Portland Community Health Clinic- Renovation Project

ASK 6

November 30, 2012

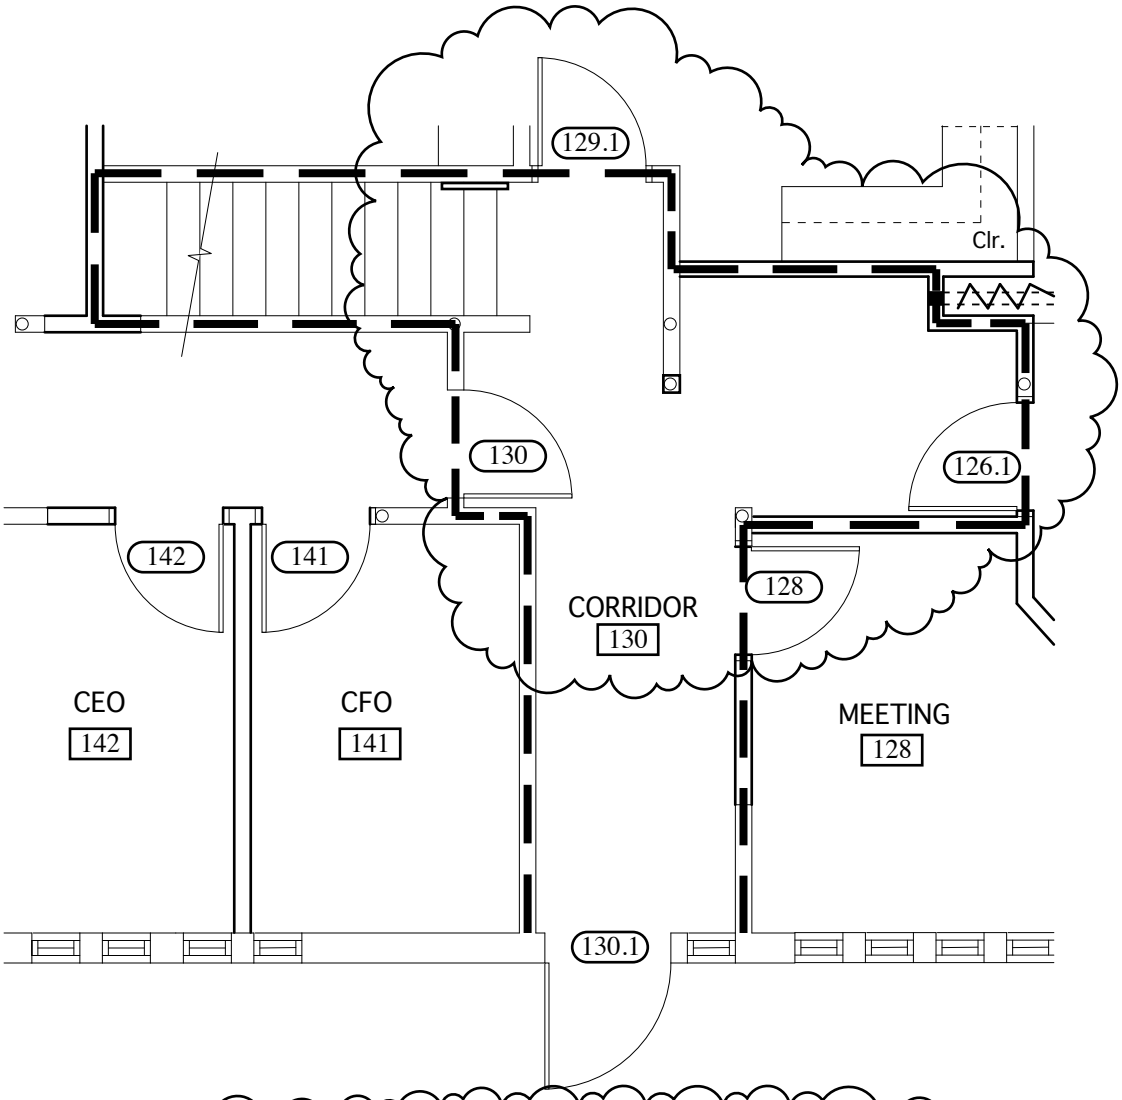
DOORS 130, 129.1, 126.1, 128 shall be changed from 60 minute rated doors w/ closers to 20 minute rated doors with closers. Partitions that these doors are located in remain 1 hour rated.
